DESCRIPTIVE REPORT

Registry No. **H-11349**

General Locality **Eastern Prince William Sound**

Sublocality **Northwest of Rocky Point**

Figure 3.

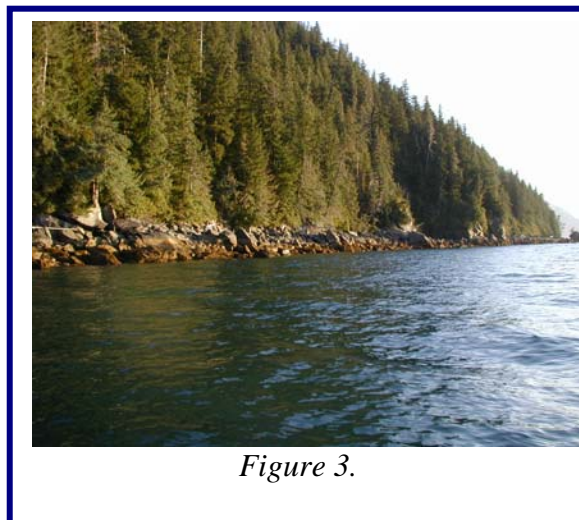
The charted (16707) MLLW between positions 61°00'12.13" N, 146°50'29.63" W; (508876.73, 6763422.22) and 61°00'12.13" N, 146°50'29.63" W; (508430.92, 6762875.35)¹⁸ was determined to be as much as 100 m inshore of the charted location. 100% SWMB showed depths of between 4.6 and 22 fathoms well within the charted MLLW line (Fig. 3).¹⁹

¹⁸ Do not concur. The geographic positions noted above are incorrect. For the northern extent: strike 61° 00' 12.13"N, 146° 50' 29.63"W and insert 61° 00' 20.16"N, 146° 50' 09.05"W. For the southern extent: strike 61° 00' 12.13"N, 146° 50' 29.63"W and insert 61° 00' 02.52"N, 146° 50' 38.82"W.

¹⁹ Concur. Chart area based on the current survey information.
